FIELD OBSERVATION REPORT

Lincoln Trail Elementary School, Hardin County Schools, Elizabethtown, KY 201752 -CA8

Report No: 17

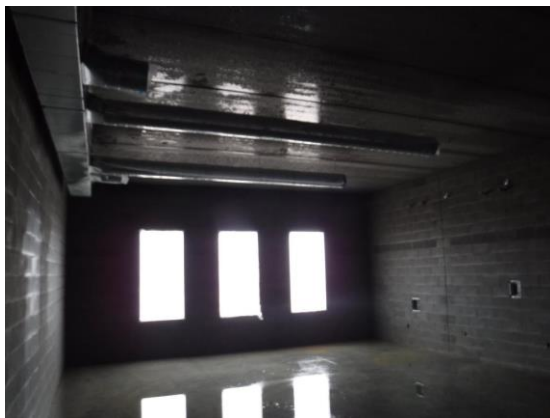
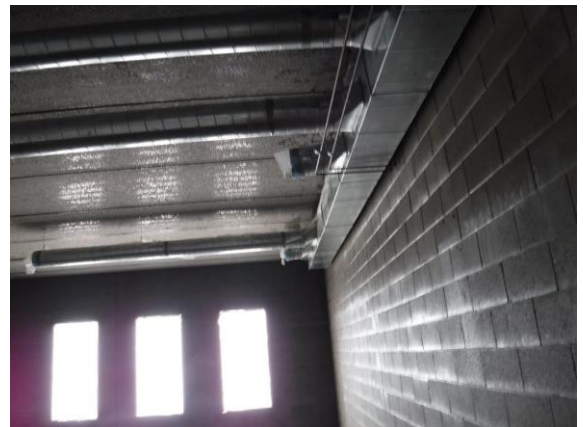
- r) The concrete planks above the first floor are dripping water and the first floor slabs are retaining water. The bulk of the water coming into the first floor is from the mechanical penetrations through the concrete planks. The water is trapped in the rooms by the raised Skudo protection board system in the corridors.

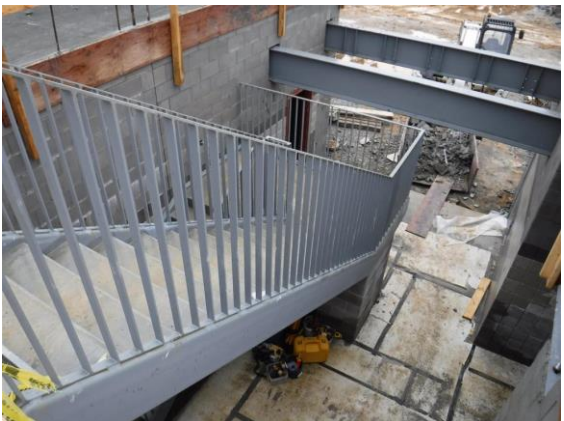
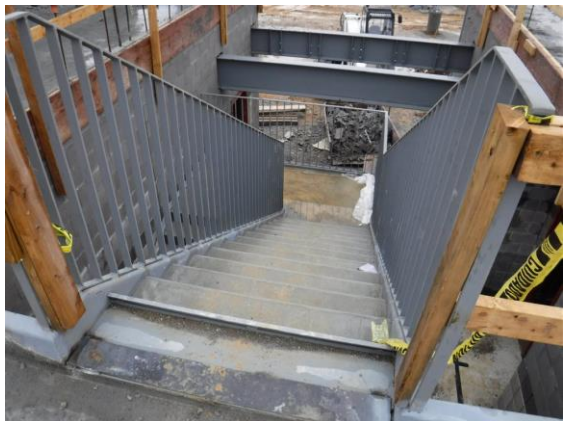
- u) The steel stairs and railings are in place in Area B. Since they are exposed to the elements until the roof is in place, these need to be monitored for rust. Missing primer needs to be replaced and any rust that is discovered needs to be removed as soon as possible.
